Draft PRE-APPLICATION CONFERENCE REPORT
Relyea Subdivision (2025-50-PAC)

Meeting conducted on Wednesday October 28, 2025 at 2:00 p.m.

Site Address	31010, 31012, and 31008 NW Spencer Road, Ridgefield, WA 98642/ Parcels 211217000, 211458000, 211450000, 211206000, 211286000, & 211525000
Legal Description	The property contains six (6) parcels which are located within the NE ¼ of Section 09, Township 4 North, Range 1 East of the Willamette Meridian
Applicant	Nikole Duke Hinton Development 14040-A NE 3 rd Court, 106 Vancouver, WA 98685 nikole@hintondevelopment.com
Applicant's Representative	Scott Taylor SGA Engineering 2005 Broadway Vancouver, WA 98663 staylor@sgaengineering.com
Property Owner	Same as applicant
Proposal	The applicant is requesting to divide approximately 66.79 acres into 153 single-family residential lots located in the LDR-7.5 zone with a sensitive utility corridor overlay. The project includes at the minimum; mass grading, public street improvements, public utility improvements and critical areas permits.
Date of Conference	October 28, 2025

Figure 1. Priority Habitat Streams and Buffers within Project Site

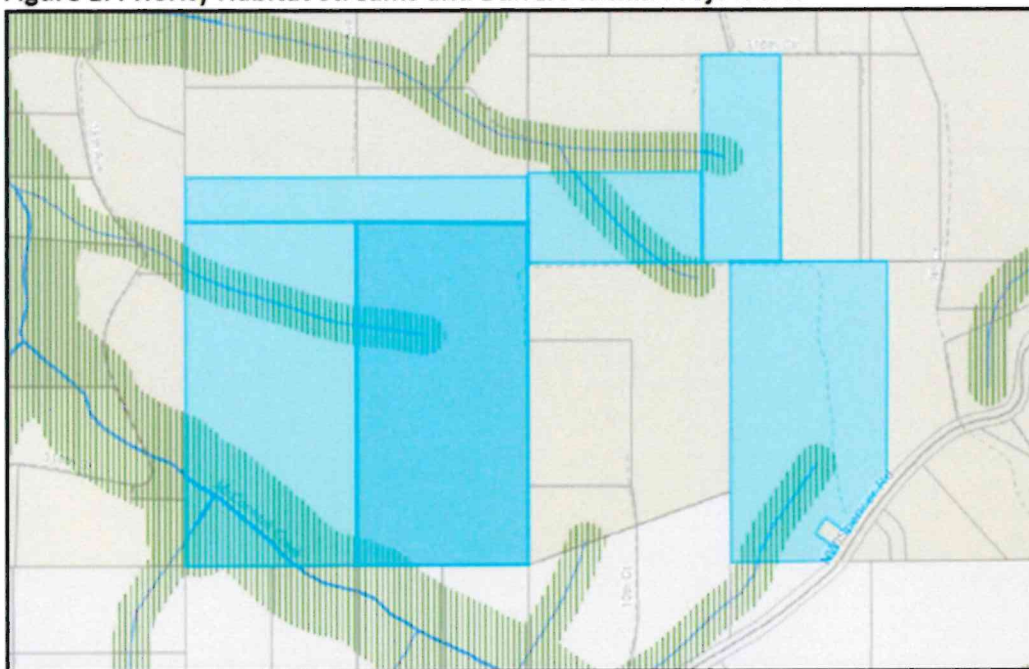
Clark County MapsOnline shows that McCormick Creek, a Type F water with fish habitat, crosses the site at the southwest corner of Parcel 211286-000. Additional unnamed, non-fish-bearing streams (identified as Type NP and Type NS waters) also traverse the property. Fish-bearing and non-fish-bearing waters are further defined in WAC 222-16-030.

Variable-width riparian habitat conservation areas are mapped along these streams. See Figure 1 for approximate stream and buffer locations. Site boundaries are shown in blue.

Development within riparian areas should be avoided; if unavoidable, a mitigation plan is required to compensate for the loss of habitat, in compliance with LCMC 18.300.090(2). Mitigation plans must demonstrate no net loss of riparian habitat in accordance with LCMC 18.300.100 and 18.300.120. The critical areas report and mitigation plan must be submitted with the preliminary plat application.

Buffer Reductions: The City’s critical areas ordinance permits buffer reductions of Type N streams up to 50 percent where the riparian area is currently impacted or contains non-native vegetation (e.g., grass or pasture), per LCMC 18.300.090(2)(l). The applicant must demonstrate that the proposed reduction will not significantly reduce water quality or habitat functions and must provide a buffer enhancement plan.

Figure 2. WDFW Priority Habitat and Species (PHS) Map

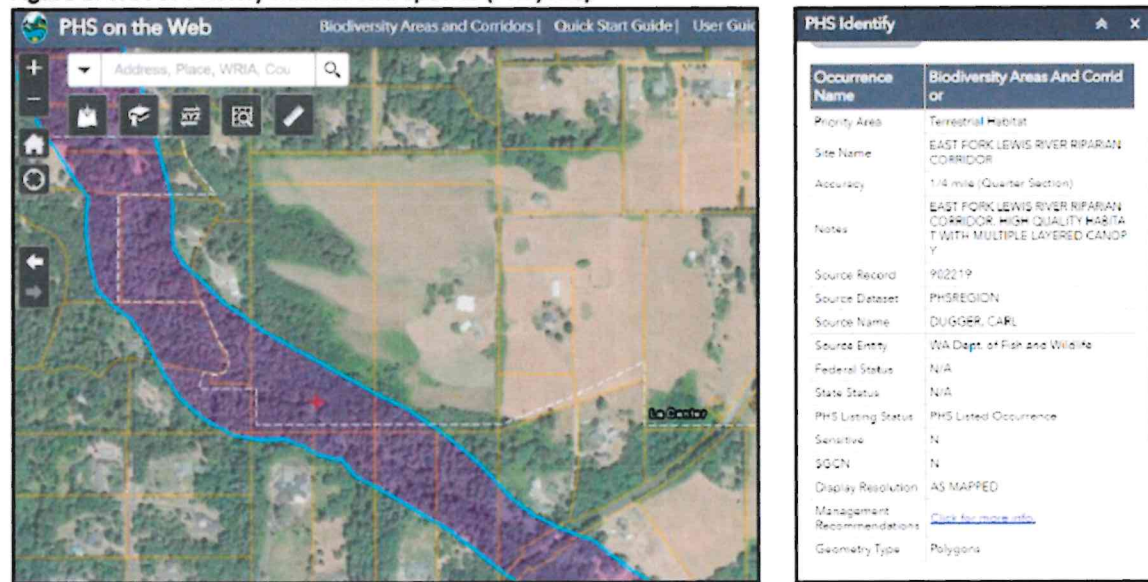
Using the WDFW Priority Habitat and Species (PHS) Map, the East Fork Lewis River Riparian Corridor runs along the southwestern portions of the site and is generally consistent with the alignment of McCormick Creek and associated buffer. Riparian areas are fish and wildlife habitat conservation areas under the critical areas ordinance and development in these areas requires a critical areas permit.

Figure 3. Slopes and Geologic Hazard Map

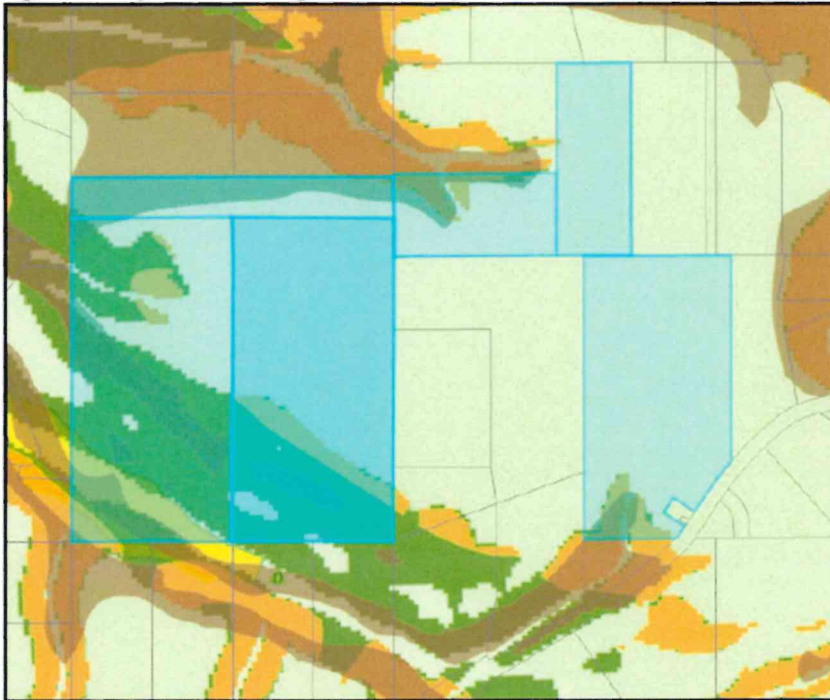
Clark County maps portions of the project site as a severe erosion hazard area (Figure 3), which is a regulated geologically hazardous critical area. Development in these areas is prohibited unless the applicant meets the requirements of LCMC 18.300.090(4)(b)(i) and 18.300.090(4)(c & e).

This includes erosion hazard area buffers as recommended in an approved geotechnical report. The applicant must also provide an erosion control plan that complies with LCMC 18.300.090(4)(e)(ii).

Pictures of Spencer Road Deficiencies

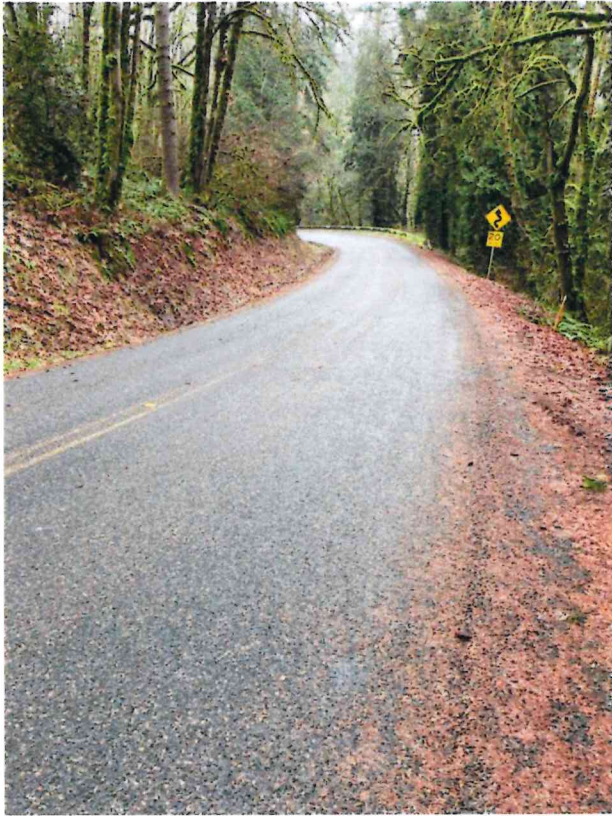
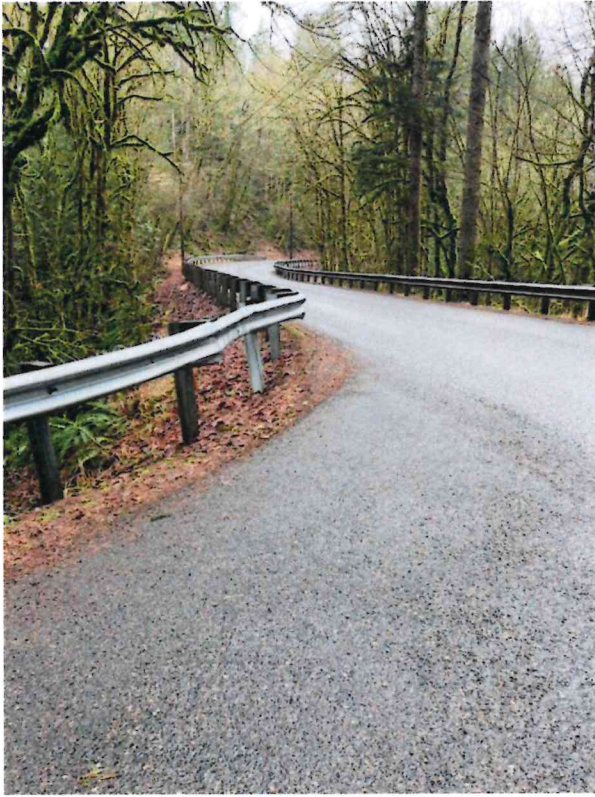
Spencer Road is only 22-feet wide and has subgrade failure in places. Section 12.10.330 of LCMC— Load limits, allows the city to prohibit vehicles of over 20,000 lbs at all such times as may be necessary, so as to prevent destruction of roadway surfaces. In addition, the Engineering Standards section 1.00 Requirements for Public Improvements states that compliance with these Standards does not relieve the designer of the responsibility to apply sound professional judgment to protect the health, safety, and welfare of the general public. Additionally, these are minimum standards, special site conditions and environmental constraints may require a greater level of protection than would normally be required under these Standards. The designer must apply these Standards bearing in mind these constraints.

Spencer Road currently has subgrade failure and several potholes and pavement cracking and has load limitations as stated above. Additional average daily traffic from the development, will potentially add significant damage to the road. Construction vehicles and trucks accessing the site for this development will severely impact the condition of Spencer Road. Road reconstruction, as well as road resurfacing will need to be done to support the Relyea Development. Some mitigation will need to be done for impacts to Spencer Road by the developer. **The city will work with the developer to contribute public funding along with contribution from the developer for repair Spencer Road to support the proposed traffic current and future traffic created by the development.** Collaboration between the city and the developer for mitigated costs will likely need to be discussed with the applicant.
